**STANDARD SPECIFICATIONS
AND TECHNICAL PARAMETERS
FOR TRANSFORMERS AND
REACTORS (66 kV & ABOVE
VOLTAGE CLASS)**

**GOVERNMENT OF INDIA
MINISTRY OF POWER
CENTRAL ELECTRICITY AUTHORITY**

विषय: Amendment No. 1 to “Standard Specifications and technical Parameters for Transformers and Reactors (66 kV & above voltage class)”-reg.

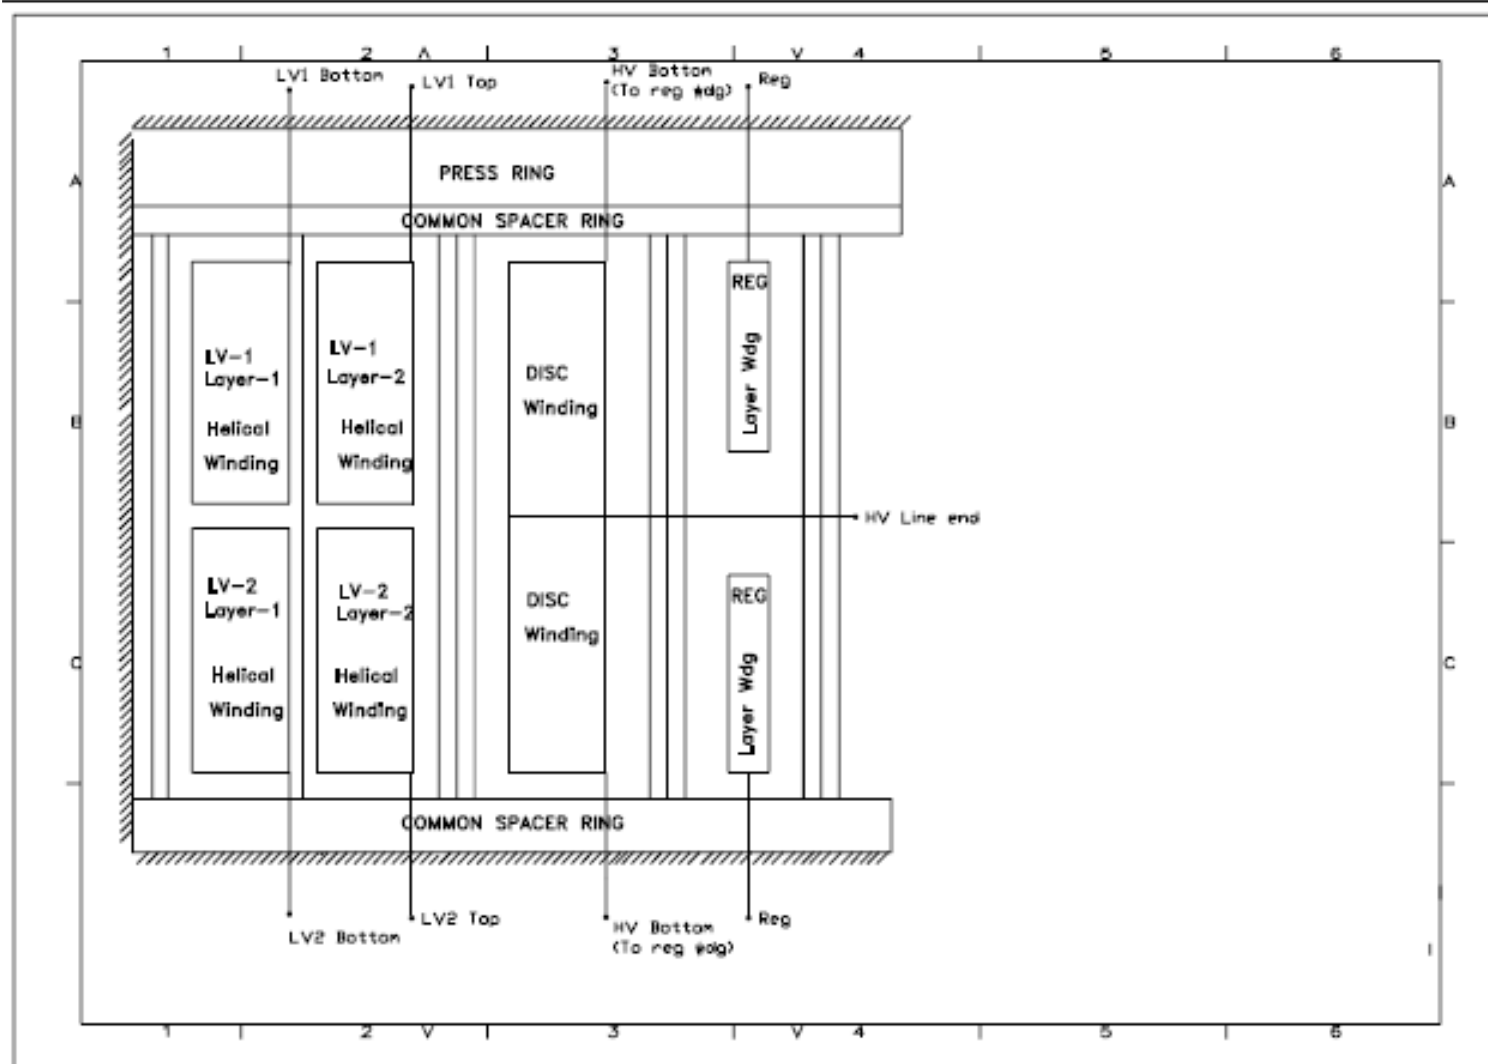
Representation has been received from multiple organizations citing that presently none of the Transformer manufacturer has got their design of 765 kV class and 500 MVA, 400 kV class transformer tested for dynamic short circuit withstand capability and process of getting the design tested would take approximately 15-18 months and only after successful testing subsequent units can be manufactured which will further take few months depending upon availability of material and capacity in the works. Manufacturers are in no position to deliver the transformer of tested design within next 24 Months. This scenario could delay the completion schedule of many transmission projects, specially associated with the evacuation of renewable generation.

To deliberate the issue of DSC requirement for the above mentioned transformers, a meeting of the committee under Chairmanship of Member (Power System) was held on 28.08.2021. After detailed deliberations

following amendment in clause 7 of Chapter 2 of “Standard Specification and Technical Parameters for Transformers and Reactors (66 kV and above)” was finalized:

Existing Provision	Amended Provision
7.0 DYNAMIC SHORT CIRCUIT TEST REQUIREMENT AND VALIDITY The transformer, the design of which is similar to the offered transformer, should have been successfully tested for short circuit withstand capability as per IS 2026 Part-5 in line with the requirement of CEA (Technical Standards for Construction of Electrical Plants and Electric Lines) Regulations. The criteria for similar transformer is specified in Annexure-J. The relevant Test Report/certificate shall be enclosed along with bid. Further, design review of offered transformer shall be carried out based on the design of reference transformer, which has already been subjected to Short circuit tests in lieu of repetition of Short circuit tests. In case, manufacturer has not conducted short circuit test earlier, the same shall be carried out on offered transformer. A format (forms part of Annexure-J) filled with data of a typical sample case has been prepared for reference and guidance of utility to compare a Short Circuit tested transformer with the offered transformer in order to verify the similarity criteria as per Annexure J.	7.0 DYNAMIC SHORT CIRCUIT TEST REQUIREMENT AND VALIDITY The transformer the design of which is similar to the offered transformer, should have been successfully tested for short circuit withstand capability as per IS 2026 Part-5 within last 5 years. The criteria for similar transformer is specified in Annexure-J. The relevant Test Report/certificate shall be enclosed along with bid. Further, design review of offered transformer shall be carried out based on the design of reference transformer, which has already been subjected to Short circuit tests in lieu of repetition of Short circuit tests. In case, manufacturer has not conducted short circuit test earlier, the same shall be carried out on offered transformer. However, considering the fact that dynamic short circuit tested design is not available for 765 kV voltage class Auto Transformer & 500 MVA, 400 kV voltage class Auto Transformer and testing of these transformers would require some more time, the above requirement of Dynamic short circuit (DSC) withstand test for these transformers shall be applicable for the projects for which bid invitation date is after 31st August 2023. For these transformers, theoretical evaluation of the ability to withstand the dynamic effects of short circuit, based on calculation and consideration of the design characteristics and manufacturing practices, shall be carried out as per IS 2026-5/IEC 60076-5. A format (forms part of Annexure-J) filled with data of a typical sample case

has been prepared for reference and guidance of utility to compare a Short Circuit tested transformer with the offered transformer in order to verify the similarity criteria as per Annexure J
